DWG. NO. 150-045082

SERVICE BULLETIN

EQUIPMENT: IDU-III

BULLETIN NUMBER: WSB IDU-III-21 Revision B

Figure 5 Speed Settings Page

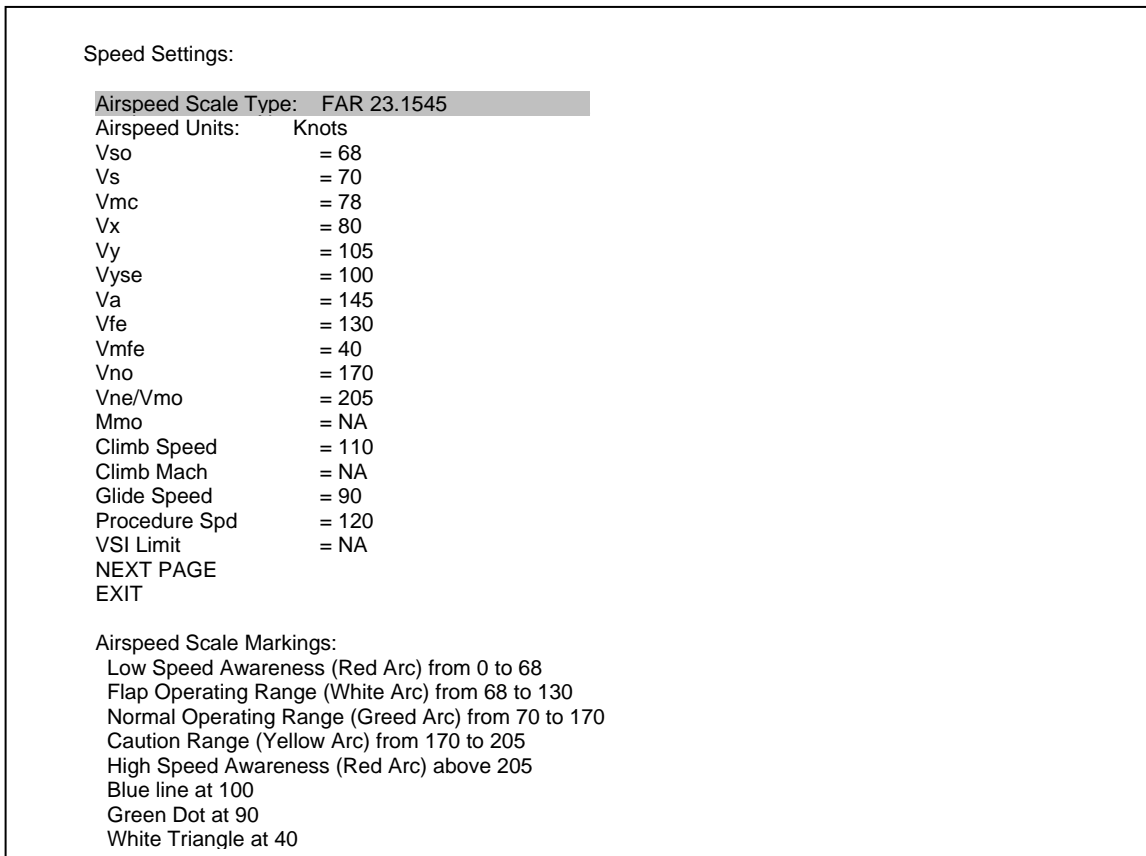
NOTE: The following changes to the Speed Settings page are:

Vyse changes to Vnepo when FAR 27.1545 or FAR 29.1545 are selected.

Vmfe changes to “Wht Triangle” when FAR 27.1545 or FAR 29.1545 are selected.

VSI Limit is added when FAR 27.1545 or FAR 29.1545 are selected.

“Blue line” is replaced with “Red/White Hashed Line” when FAR 27.1545 or FAR 29.1545 are selected and is set by Vyse or Vnepo.

CAUTION: VSI Limit for all B407 installations under STC SR02203AK must be set to “+2000”.
